# Access Compliance Report

## Public Rights-of-Way

### (Curb Ramps)

Intersection ID: 48450	Main Street: DUSTY_SADDLE_RD	Cross Street: RED_RUST_LN	Location: NW
ADA ID: 9750B35653BC	Ramp Type: Perp	Initial Pass/Fail: Fail	Overall Compliance: No
Severity Score: 8.75			
Codes/Mitigation Info/Possible Solution		Field Measurements/Component Compliance

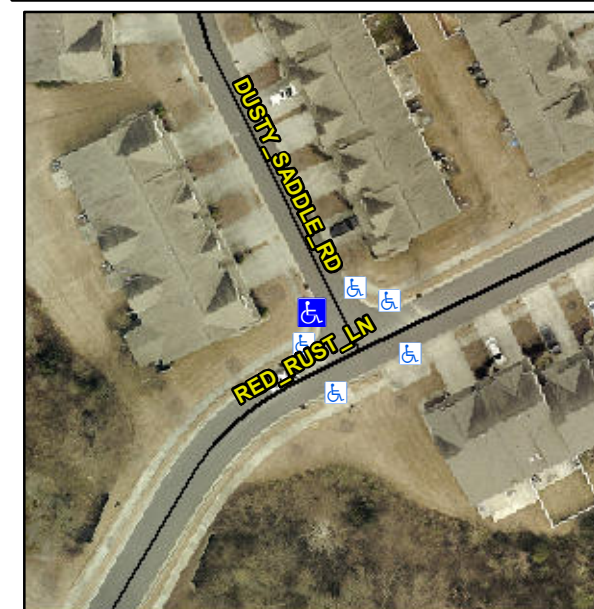
**Not Found, R304.5.1**

Compliance	Description	Data	Compliance	Description	Data
N/A	Ramp Length (in)	38.0	Yes	Ramp Slope (%)	5.1
No	Ramp Width (in)	46.0	Yes	Ramp XSlope (%)	0.3
N/A	Flare Type LT	N/A	N/A	Flare Type RT	N/A
N/A	Flare Slope LT (%)	N/A	N/A	Flare Slope RT (%)	N/A
N/A	Flare Traversable LT?	N/A	N/A	Flare Traversable RT?	N/A
N/A	Landing Length (in)	N/A	N/A	DWS Provided?	N/A
N/A	Landing Width (in)	N/A	N/A	DWS Contrast?	N/A
N/A	Landing Slope (%)	N/A	N/A	DWS Length (in)	N/A
N/A	Landing X Slope (%)	N/A	N/A	DWS Full Width?	N/A
N/A	Landing Curb? (Y/N)	N/A	N/A	DWS Offset (in)	N/A
N/A	Shared Landing?	N/A			
N/A	Gutter Ponding?	N/A	N/A	Gutter Slope (%)	N/A
N/A	Gutter Lip Ht (in)	N/A	N/A	Gutter X Slope (%)	N/A
N/A	Painted X Walk1?	No	N/A	Painted X Walk2?	N/A
	X Walk 1 Direction	To NE		X Walk 2 Direction	N/A
N/A	X Walk 1 Width (in)	N/A	N/A	X Walk 2 Width (in)	N/A
	X Walk 1 Slope (%)	0.7		X Walk 2 Slope (%)	N/A
	X Walk 1 X Slope (%)	0.7		X Walk 2 X Slope (%)	N/A

N/A	Ramp inside XWalk1?	N/A	N/A	Ramp inside XWalk2?	N/A
	Road Slope (%)	N/A	N/A	Clear Space?	N/A
	Road X Slope (%)	N/A	N/A	Clear Space to XWalk (in)	N/A
N/A	Any Obstructions?	N/A	N/A	Storm Grate/Utility Hazard?	N/A
	Obstruction Type			Storm Grate/Utility Type	
		N/A			N/A
		Yes		Surface Condition? (G/P)	Good

**Remove & Replace Entire Ramp.**
